SCHOOL OF LAW

Interdisciplinary Environmental Clinic

July 20, 2015

Re: 2015 Monitoring Network Plan

Figure 1. Modeled peak concentration areas near Ameren's Labadie plant.

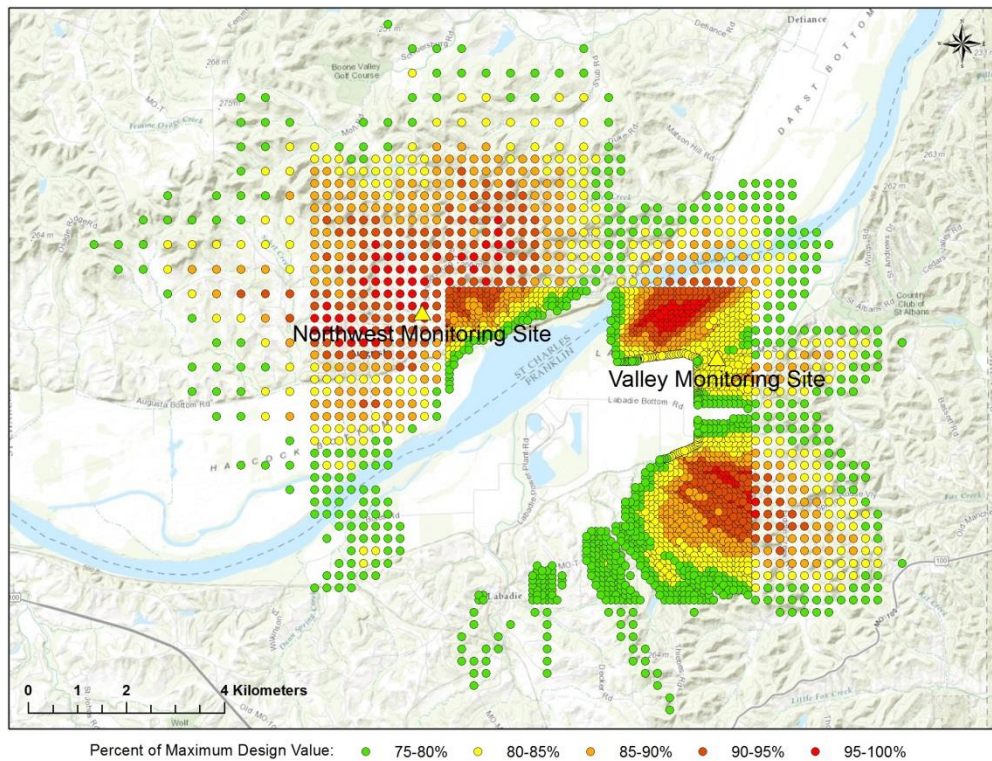
In our April 13, 2015 comments to DNR on Ameren’s proposed new Labadie monitoring sites, attached as Exhibit 1, we demonstrated that one of the proposed sites – the Valley site – is not located in any of the areas where Ameren’s modeling predicts peak SO₂ concentrations are expected to occur. Ameren’s modeling identified three distinct areas where the highest SO₂ concentrations are expected to occur and where high concentrations are expected to occur most frequently. These areas are located northwest, northeast, and southeast of the plant and are shown in Figure 1 below. However, only one of the two proposed Labadie monitoring sites – the Northwest site – is located in one of these peak concentration areas (the one located northwest of the plant). The Valley site is located between the other two peak concentration areas, in an area where the modeled concentration is only about 80 percent of the maximum concentration predicted by the model. As a result, it is unlikely to capture maximum ambient SO₂ concentrations and should be relocated to the peak concentration area northeast of the plant.

In addition, DNR should also require the installation of a third monitor in the peak concentration area southeast of the plant lest anticipated maximum ambient SO₂ concentrations in this area – which are likely to have implications for NAAQS compliance – go undetected by the Labadie SO₂ monitoring network.

Figure 2. DNR model results and polygons drawn around high concentration areas.

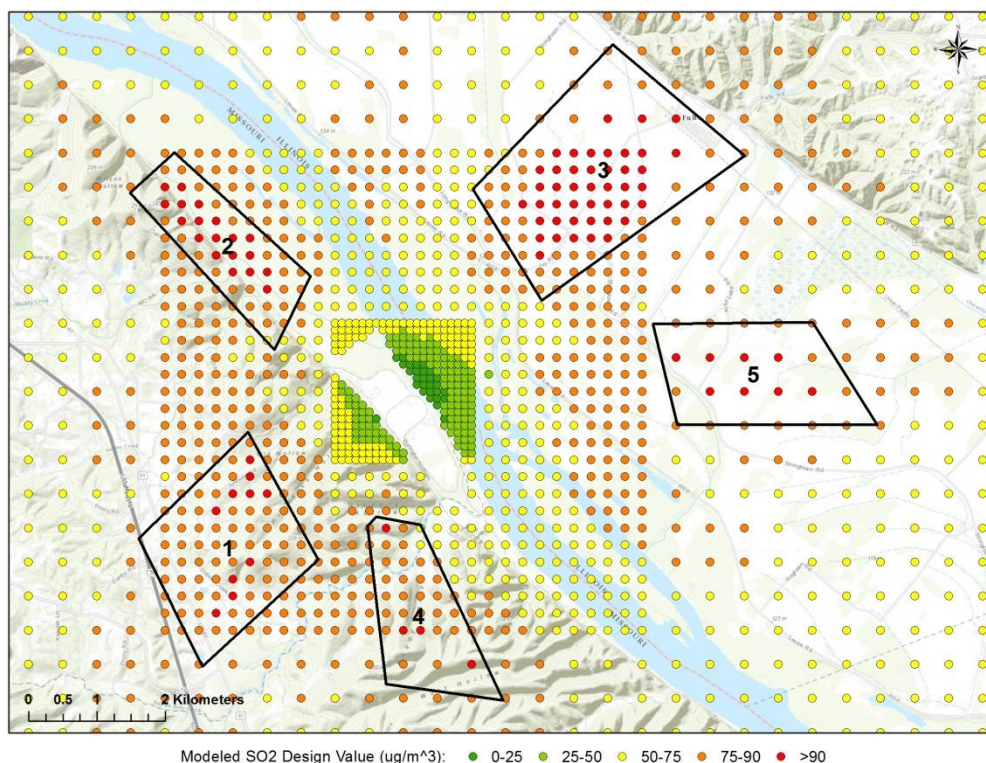
However, DNR's analysis of its modeling is based on a methodology that inherently biases the results. DNR used a telescoping receptor grid in its modeling; specifically, it used a 100-meter receptor spacing out to 1 kilometer, a 250-meter spacing out to 3.5 kilometers, a 500-meter spacing out to 10 kilometers, and a 1,000-meter spacing out to 50 kilometers. In order to identify areas where peak SO₂ concentrations are expected to occur, it plotted the predicted SO₂ design value at each receptor and drew polygons around high concentration areas by including all receptors with concentrations greater than 90 ug/m³. This is shown in Figure 2 below. DNR then

counted the number of high concentration receptors (i.e., receptors with concentrations greater than 90 ug/m³) in each polygon and ranked the polygons from highest to lowest in terms of the number of high concentration receptors they contained. The results of this analysis are summarized in Table 1 below.

However, because DNR used a telescoping receptor grid, and because the polygons it drew to indicate areas of high concentration are located in a region where the receptor grid spacing varies from 250 to 500 meters, DNR's counts of high concentration receptors in each polygon and its subsequent ranking of the polygons based on those counts are significantly biased. Some of DNR's polygons are likely to have more high concentration receptors than others just by virtue of the fact that the receptors in those polygons are spaced more closely together than they are in other polygons. For example, almost all of the receptors in polygons 1 and 2 are spaced 250 meters apart, whereas all of the receptors in polygon 5 are spaced 500 meters apart. As a result there are many more receptors – including more high concentration receptors – in polygons 1 and 2 than in polygon 5 despite the fact that all three polygons are similar in size (polygon 5 is slightly larger than polygon 2 and slightly smaller than polygon 1).

One way to eliminate the counting bias resulting from DNR's use of a telescoping receptor grid is by ranking the polygons based on the percentage instead of the absolute number of high concentration receptors within each one. This effectively adjusts for the fact that certain polygons, e.g., polygons 1 and 2, are likely to have more high concentration receptors than others, e.g., polygon 5, just by virtue of the fact that the receptors in those polygons are spaced more closely together. The results of this analysis are summarized in Table 2 below. Polygon 3 is still ranked the highest. However, polygon 5 is ranked second-highest instead of polygon 2, which drops to third-highest – displacing polygon 1 from the top three.

Figure 3. DNR model results for uniform 250-meter receptor grid.

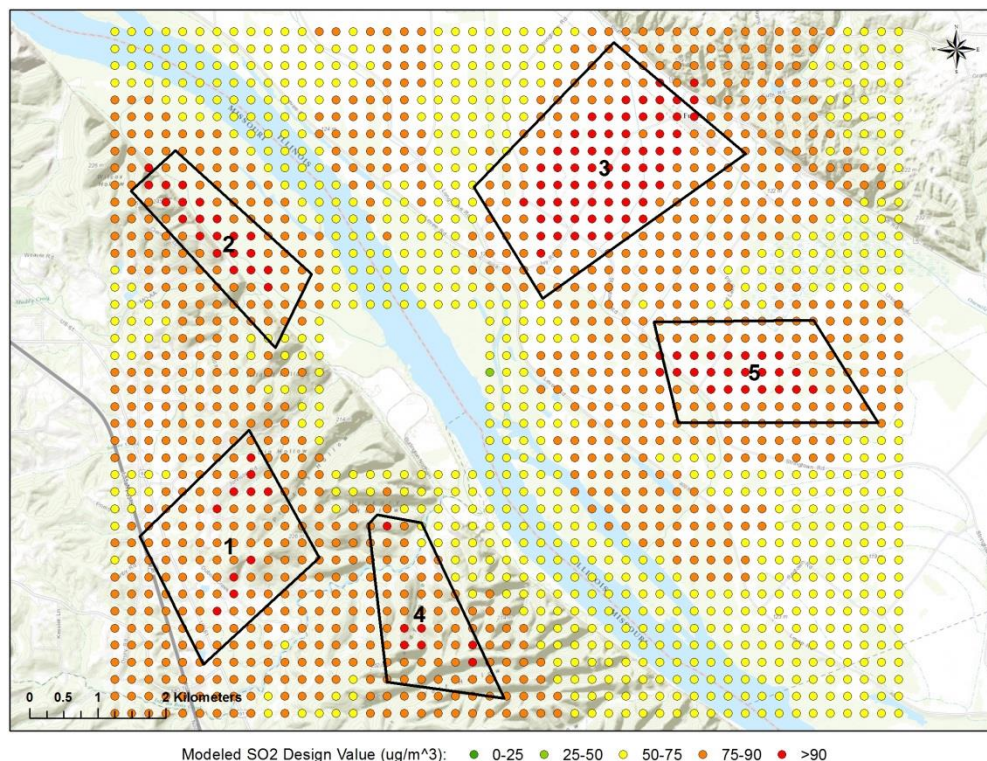
A better way to eliminate the counting bias resulting from DNR's use of a telescoping receptor grid is to replace the telescoping grid with a uniform grid so the receptor spacing is the same in all five polygons. To determine how this would affect receptor counts and polygon ranks, we re-ran DNR's model using a uniform 250-meter receptor spacing and analyzed the results using DNR's methodology. The results are shown in Figure 3 below, and the number of high concentration receptors in each polygon and the ranking of polygons from highest to lowest in terms of the number of high concentration receptors they contain are summarized in Table 3 below. We also ranked the polygons based on the percentage instead of the absolute number of

When modeled with a uniform receptor grid, the three highest ranking polygons – both in terms of the number and percentage of high concentration receptors they contain – are 2, 3 and 5, **not** 1, 2 and 3 as DNR's flawed analysis concluded. These are the areas predicted to have the highest modeled impacts and thus where SO₂ monitoring sites should be located. An analysis of the top 10, 25, and 50 receptors supports this conclusion. All but one of the top 10 receptors are located within polygon 3, all but one of the top 25 receptors are located within polygons 2 and 3, and all but one of the top 50 receptors are located within polygons 2, 3 and 5. This is shown in Figure 4 below, which includes a filled contour plot of modeled design values that clearly shows how much larger the peak concentration areas are in polygons 2, 3 and 5 compared to the other polygons.

Figure 5. Ameren's proposed SO₂ monitoring sites relative to DNR's polygons. Peak concentration areas (>90 ug/m³) are shaded red.

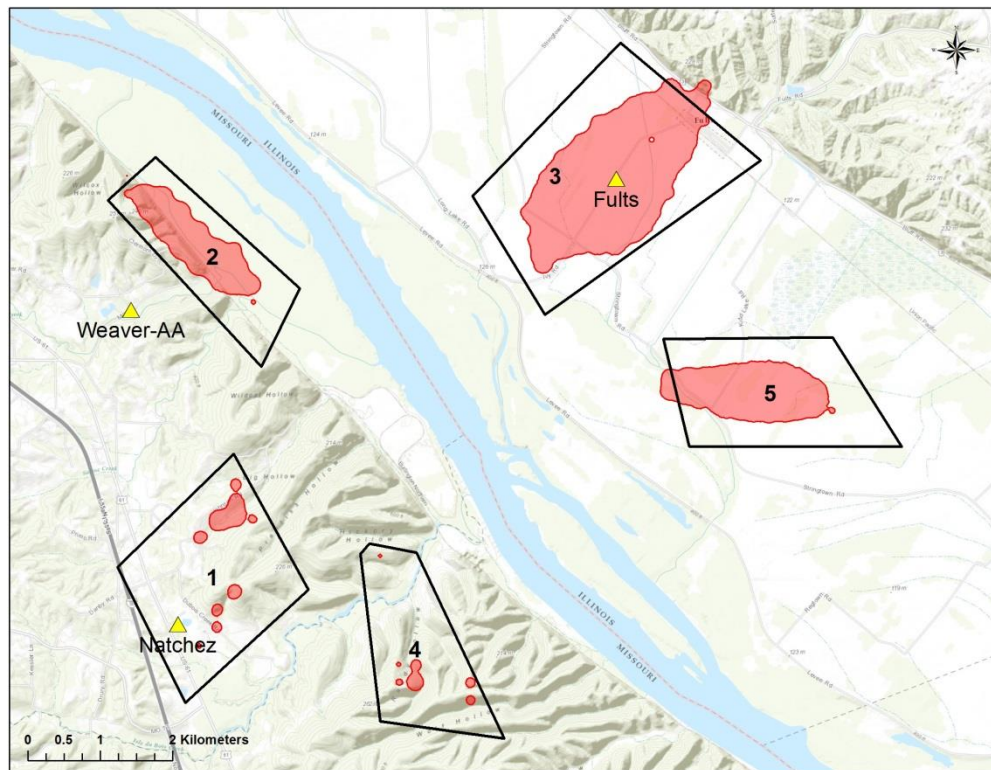
The locations of Ameren's proposed SO₂ monitoring sites – dubbed Fults, Natchez and Weaver-AA – relative to DNR's polygons are shown in Figure 5 below. Of the three proposed sites, only the Fults site, which is inside the peak concentration area within polygon 3, is properly located. The Weaver-AA site, which Figure 2 of Monitoring Network Plan Appendix 5 incorrectly shows being within polygon 2, is actually located outside of it based on the site coordinates provided in Plan Appendix 1. Hence it is not properly located. Nor is the Natchez site, which should be located within polygon 5 instead of polygon 1 because polygon 5 has higher modeled impacts.

Because they are not properly located, neither the Natchez nor Weaver-AA monitoring sites will adequately represent Rush Island's SO₂ air quality impact. Therefore, both sites should be relocated. The Weaver-AA site should be located inside the peak concentration area within polygon 2 and the Natchez site should be located inside the peak concentration area within polygon 5 as shown in Figure 6 below. Alternatively, the Natchez site could be moved inside the peak concentration area within polygon 1 and a fourth monitor added inside the peak concentration area within polygon 5 as shown in Figure 7 below. The recommended monitor locations shown in Figures 6 and 7 are easily accessible and appear to meet EPA siting criteria and have ready access to power.

Figure 1. Receptors with modeled design values 75 percent of the maximum design value.

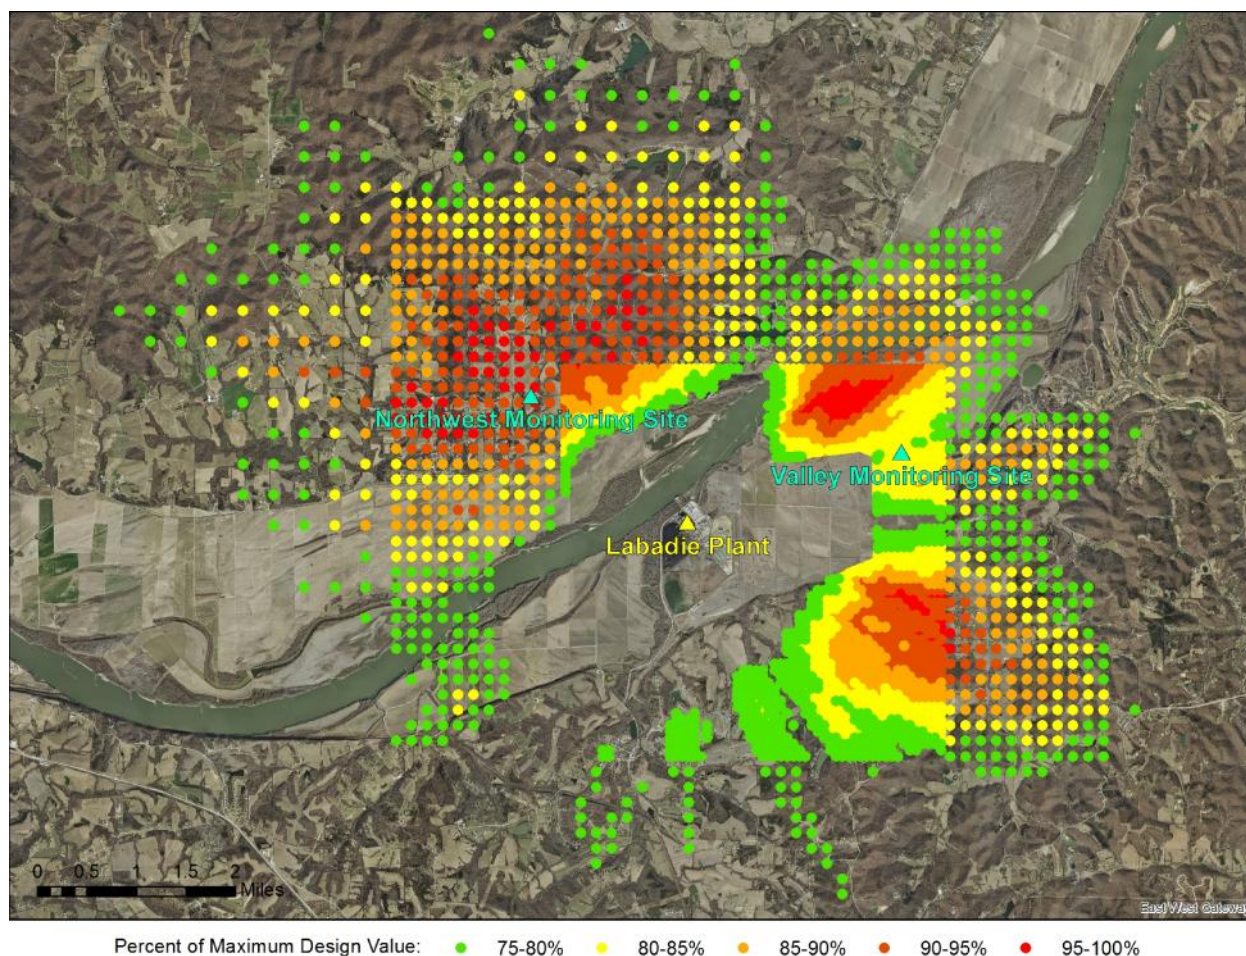
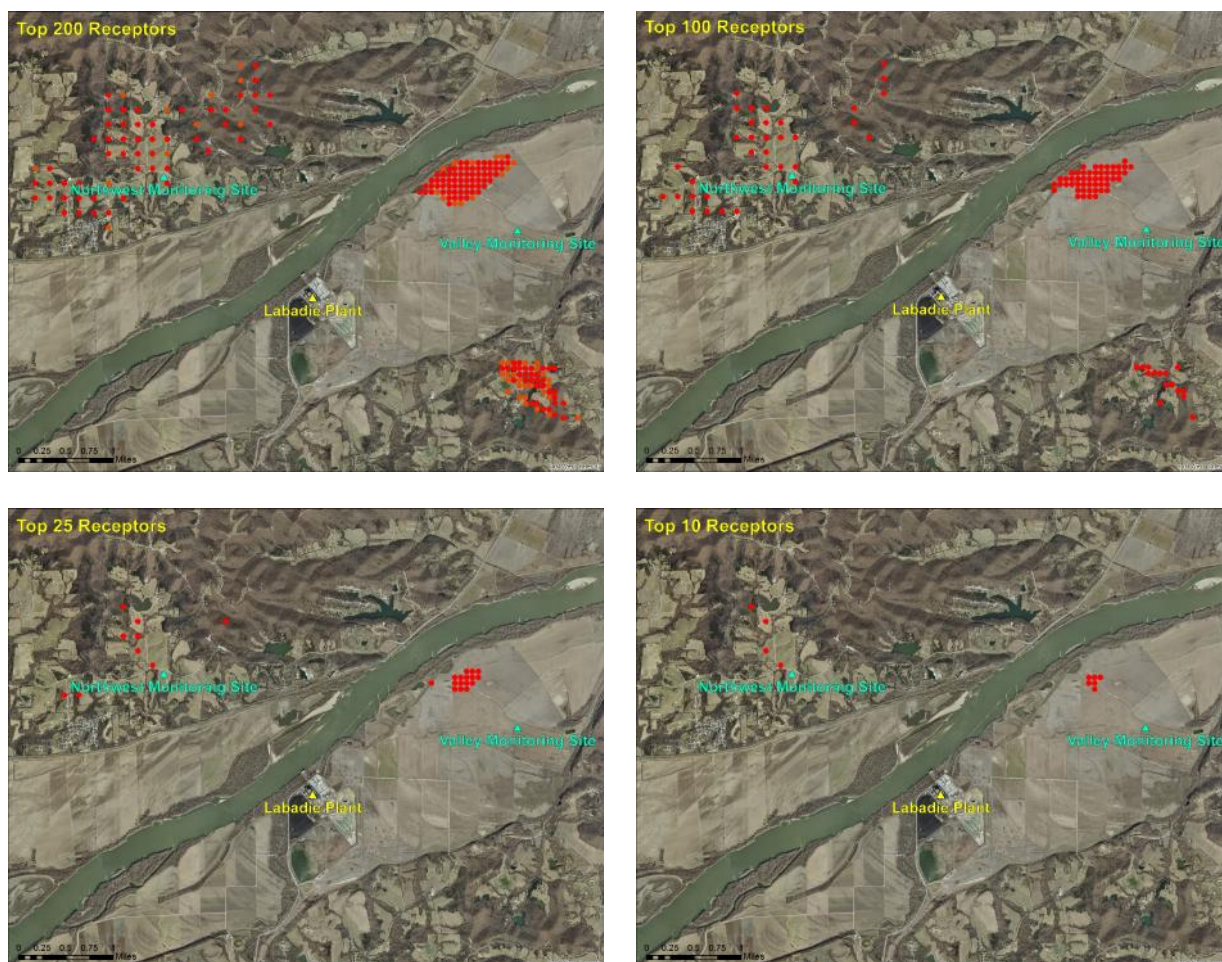
Figures 1 and 2 reveal three distinct areas where modeled design values are in excess of 95 percent of the maximum modeled design value and where the majority of the top 200 receptors (and all of the top 100, 25 and 10 receptors) lie. These areas, located northwest, northeast, and southeast of the Labadie Energy Center, are where the modeling predicts peak 1-hour SO₂ concentrations are expected to occur. Furthermore, although a rigorous comparison is not possible without detailed receptor data, a simple visual comparison of Figures 1 and 3 indicates that the areas where peak 1-hour SO₂ concentrations are expected to occur (i.e., where modeled design values are in excess of 95 percent of the maximum modeled design value) overlap with the areas where daily maximum 1-hour SO₂ concentrations most frequently exceed 75 percent of the maximum modeled design value. Monitoring stations located in these areas would have the greatest chance of identifying peak SO₂ concentrations in ambient air, which is the primary objective of source-oriented monitoring and an absolute necessity when monitoring to assess compliance with the NAAQS.

However, only one of Ameren's proposed monitoring sites, the northwest site, is located in one of the three peak concentration/high frequency areas predicted by the modeling (the one located northwest of the plant). No monitoring sites are proposed in the peak concentration/high frequency areas located northeast or southeast of the plant. Instead, Ameren's only other proposed monitoring site, the valley site, is located in an area where modeled design values are only about 80 percent of the maximum modeled design value and where daily maximum 1-hour SO₂ concentrations exceed 75 percent of the maximum modeled design value about half as often as they do in areas where this occurs with the greatest frequency. This makes the valley site an inappropriate site for a monitor to assess compliance with the NAAQS. Ameren's modeling predicts that ambient SO₂ concentrations will be as much as 25 percent higher in several areas around the plant than they will be at the valley site, meaning a monitoring station at the valley site could be in compliance with the NAAQS while significant violations were occurring nearby.

without building additional infrastructure, and electric power is not available. These justifications do not stand up to the barest scrutiny. The entire Labadie Bottoms is an actively farmed area, accessible only by unimproved roads that severely limit vehicular access during wet weather conditions. As such, the proposed valley monitoring site is no more accessible than a site within the peak concentration/high frequency area northeast of the plant would be, and additional road infrastructure will likely be necessary for all-weather access regardless of where in the Labadie Bottoms the monitor is located.⁴ Furthermore, electric power is not available anywhere within the Labadie Bottoms, including at the proposed valley monitoring site. Therefore, distribution infrastructure will have to be built to deliver power to any monitoring site in the Labadie Bottoms regardless of where it is located. The St. Albans Water and Sewer Authority/Franklin County PWSD #3 wastewater treatment facility, located approximately 1 kilometer east of the proposed valley monitoring site, appears to be the closest available source of electric power for monitoring sites in the Labadie Bottoms, and only a minimal amount of additional line would be necessary to deliver power to a monitor located in the peak concentration/high frequency area northeast of the plant compared to one located at the proposed valley monitoring site.

The QAPP's justification for not siting a monitor in the peak concentration/high frequency area southeast of the plant is equally flimsy. The QAPP states that the primary reason a monitor is not proposed in that area – despite the model predicting high design values and a high number of daily maximum 1-hour SO₂ concentrations in excess of 75 percent of the maximum modeled design value in that area – is because the elevated terrain there is similar to the terrain at the proposed northwest monitoring site and it was believed an additional elevated terrain site was not necessary. However, AERMOD accounts for terrain influences when calculating modeled design values, and variations in meteorological parameters, most notably wind direction, often result in peak 1-hour SO₂ concentrations occurring in different areas that have similar terrain (e.g., areas in different cardinal directions from the source). Therefore, the peak concentration/high frequency area southeast of the plant cannot be ignored simply because the terrain there is similar to the terrain in the peak concentration/high frequency area northwest of the plant. The purpose of an ambient SO₂ monitoring network is not to monitor different terrain types, but to monitor areas where peak 1-hour SO₂ concentrations are expected to occur regardless of the terrain in those areas. The QAPP also suggests that the high concentrations and frequencies predicted by the model southeast of plant are merely an artifact of the Jefferson City, MO Airport meteorology, which is influenced by the local orientation of the Missouri River valley at that met station. However, the wind roses provided in the QAPP for a number of met stations in eastern Missouri that are closer to Labadie, which the QAPP states better reflect the expected meteorology at Labadie, all show significant winds from the north or northwest, which is consistent with an area of peak concentration/high frequency southeast of the plant.

- 1) Relocate the proposed valley monitoring site to the peak concentration/high frequency area northeast of the plant; and
- 2) Add a third monitoring site in the peak concentration/high frequency area southeast of the plant.

Figure 3. Number of maximum daily 1-hour SO₂ concentrations at each receptor that exceed 75 percent of the maximum modeled design value.

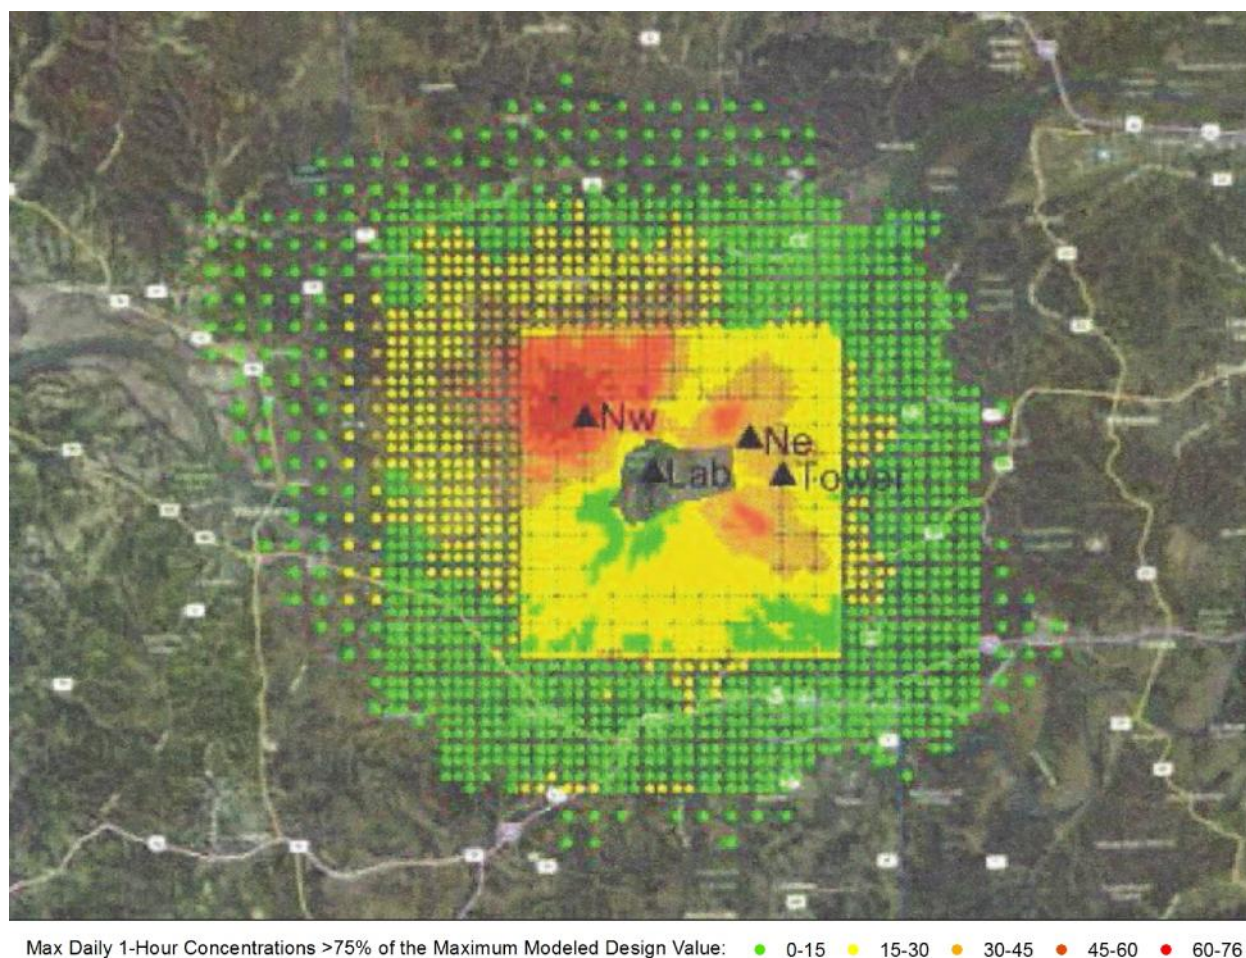
The modeling was also used to determine locations where elevated SO₂ concentrations are expected to occur most frequently given that the site selection process also needs to account for the frequency with which an area sees the daily maximum concentration.² Normally this involves counting the number of times each receptor sees the daily maximum 1-hour SO₂ concentration predicted by the model. However, the QAPP looks at it differently, counting instead the number of times the daily maximum 1-hour SO₂ concentration at each receptor exceeds 75 percent of the maximum modeled design value. Figure 3, which is reproduced from the QAPP,³ shows the number of daily maximum 1-hour SO₂ concentrations at each receptor that exceed 75 percent of the maximum modeled design value.
